**TECHNICAL BULLETIN No. 86 DATE: 23/12/10**

**SUBJECT: PDP42XR9DA Preparation for Transport**

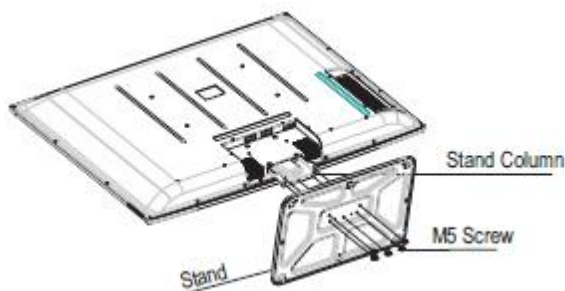
Many of this model get damaged during transport.

Impact/pressure on Stand Column cause panel to crack.

Remove the Stand Column and pack it separately, with its screws, within the carton box securely.

Remove the four screws holding the Stand Column and slide it out of the chassis.
